DESIGN REVIEW 1750 BROADWAY, OAKLAND, CA

Design Review Committee

Case File Number: ZP170064

Location:	1750 Broadway
Assessor's Parcel Numbers:	008 062301300
Proposal:	To construct a 37-story high-rise consisting of 307 residential units with 5,000 square foot of ground-floor retail space including a six-level parking garage above grade to be accessed from 19 th Street.
Applicant:	Rubicon Point Partners / Chris Relf
Phone Number:	(415) 500-6410
Owner:	1750 Broadway LLC
Case File Number:	ZP170064
Planning Permits Required:	Major Conditional Use Permit for buildings over 200,000 square feet in the CBD-P and CBD-C Zone; and Regular Design Review for new construction.
General Plan:	Central Business District
Zoning:	CBD-P / Central Business District Pedestrian; and CBD-C / Central Business District Commercial
Environmental Determination:	Environmental analysis under review
Property Historic Status:	Non-Historic Property
Service Delivery District:	Uptown
City Council District:	3
Date Filed:	07/19/17

1770 LOT LINE ELEVATION

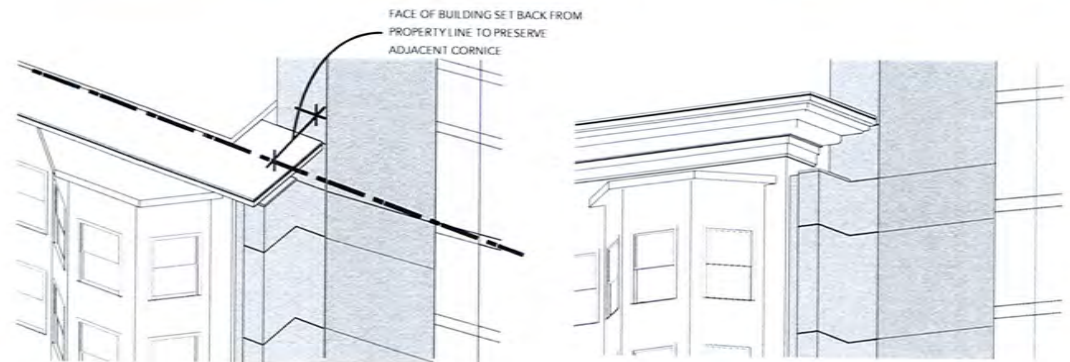
- The north, south and east garage walls need further massing relief as these are close to residential unit windows and sections of the blank garage walls would be seen from 19th Street.

POTENTIAL TROMPE L'OEIL MURAL TO VISUALLY COMPLETE THE COURTYARD
PODIUM WALL TO BE SET BACK 3FT FROM PROPERTY LINE FOR AIR AND LIGHT

BROADWAY VIEW - PODIUM - REVISED (02/05/2018)

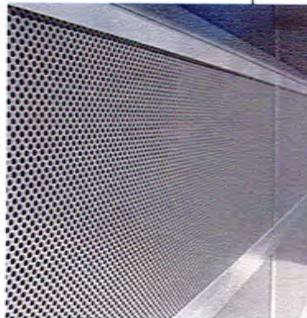
- Develop further the façade wall (garage screen) in front of the six-level parking garage facing Broadway to create a better composition and scale that is compatible to the building tower and that includes interesting design details. Also, limit the verticality of the garage screen to the top of the 7 level. The terrace on the 8 level should use instead a clear glass railing for transparency.

- Develop further the base to create a stronger composition that defines the ground-floor retail area and the building tower while maintaining a compatible transition. Include additional design features to make the residential entry more prominent and visually inviting from the street.
